# HISTORIC LANDMARK COMMISSION

# APPLICATION FOR A CERTIFICATE OF APPROPRIATENESS OCTOBER 28, 2019 C14H-2007-0040 PARRISH-FLEMING HOUSE 1410 NORTHWOOD ROAD

Google streetview photo - 2014

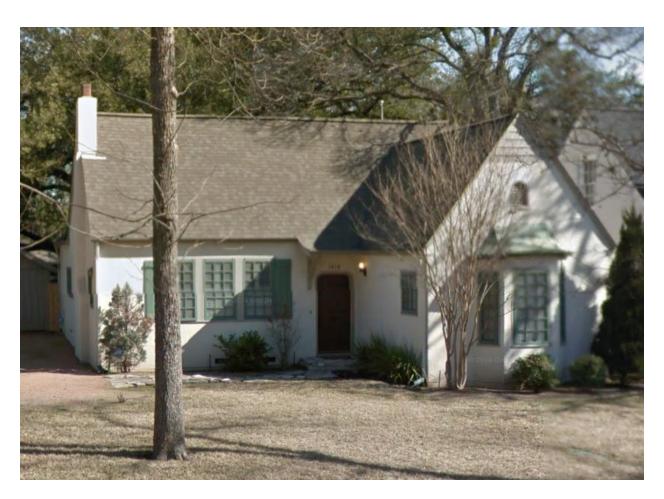
- 1) The historic character of a property will be retained and preserved. The removal of distinctive materials or alteration of features, spaces, and spatial relationships that characterize a property will be avoided.
  - Evaluation: The original windows on the house were replaced with windows that do not match the original configuration.
- 2) Each property will be recognized as a physical record of its time, place, and use. Changes that create a false sense of historical development, such as adding conjectural features or elements from other historic properties, will not be undertaken.
  - Evaluation: The original windows were 1:1 with 6:6 wooden screens; the applicant replaced the windows with 6:6 windows and no screens.
- 5) Distinctive materials, features, finishes, and construction techniques or examples of craftsmanship that characterize a property will be preserved.

Evaluation: The replacement windows do not match the original windows in terms of configuration.
- 6) Deteriorated historic features will be repaired rather than replaced. Where the severity of deterioration requires replacement of a distinctive feature, the new feature will match the old in design, color, texture, and, where possible, materials. Replacement of missing features will be substantiated by documentary and physical evidence.

- Evaluation: The applicant states that the existing windows were deteriorated beyond repair, but should have conducted a window-by-window survey to determine which, if any, of the windows could have been repaired rather than replaced. In any replacement, the replacement material should match the historic material. In this case, it did not.

No recommendation. This is a case for the Commission to decide the appropriate remedy, which may include accepting the current condition, additional reprimands, requiring the applicant to take out the current windows and replace them with 1:1 windows with 6:6 screens as originally on the house, referring the case to the appropriate department for prosecution, or recommending against the applicant's application for a tax exemption for the historic landmark. Staff believes this was an honest mistake by the applicant, but is still very disturbed by the change in the appearance of this historic landmark and recommends some sort of action at the Commission's discretion.
